Re: Integrated Development referral under s.91A of the Environmental Planning and Assessment Act 1979 for 233 and 249-259 Merrylands Road and 52-54 McFarlane Street Merrylands

Reference is made to your request for a response in relation to the proposed development described as 233 and 249-259 Merrylands Road and 52-54 McFarlane Street Merrylands (Merrylands Court Stockland) and also identified as DA 2016/127/1.

DEVELOPMENT APPLICATION NO. 2016/127/1

CUMBERLAND COUNCIL DEVELOPMENT APPLICATION 2016/127/1 RE 233 &

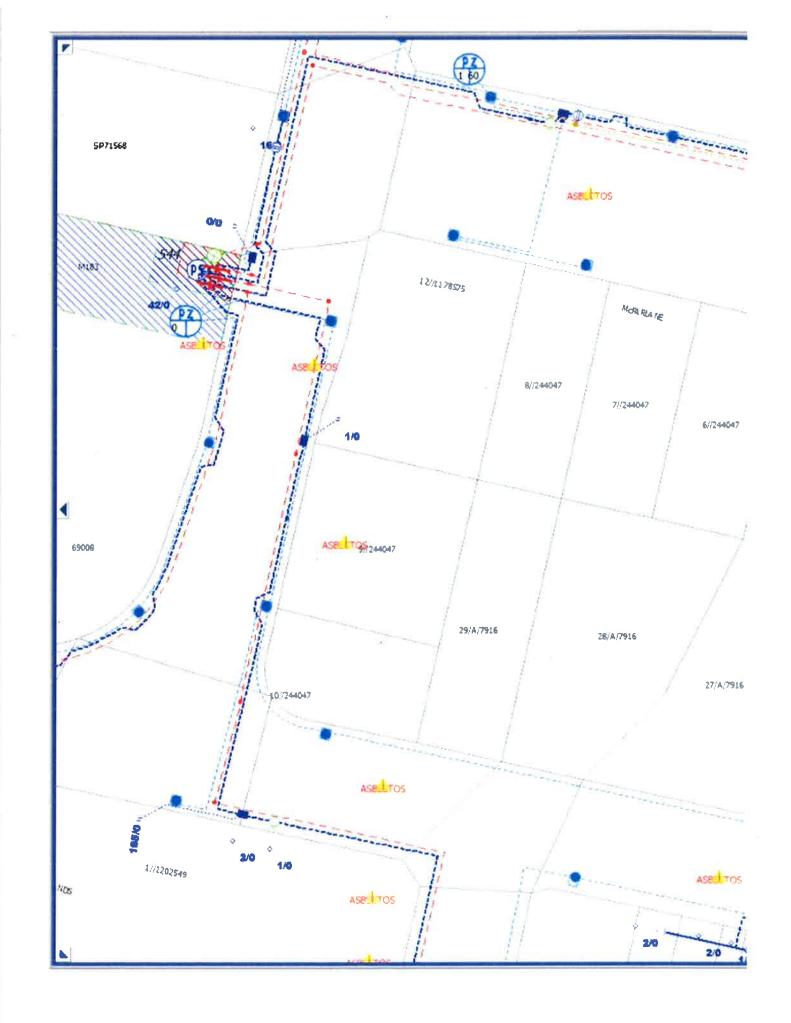
As shown in the below site plan from Endeavour Energy's G/Net master facility model, there is an easement over the site benefitting Endeavour Energy (indicated by red hatching) for a padmount substation (located on McFarlane Street) and associated cabling. There are both low voltage and 11,000 volt / 11 kV high voltage underground cables to parts of the road frontages of the site. Please note the location of any electricity infrastructure, boundaries etc. shown on the plan is indicative only and this plan is not a 'Dial Before You Dig' plan under the provisions of Part 5E 'Protection of underground electricity power lines' of the <u>Electricity Supply Act 1995</u> (NSW).

- o Not install or permit to be installed any services or structures within the easement site.
- o Not alter the surface level of the easement site.
- o Not do or permit to be done anything that restricts access to the easement site without the prior written permission of Endeavour Energy and in accordance with such conditions as Endeavour Energy may reasonably impose.

If the proposed works will encroach/affect Endeavour Energy's easements contact must first be made with the Endeavour Energy's Easements Officer, Philip Wilson, on 9853 7110 alternately Philip.Wilson@endeavourenergy.com.au.
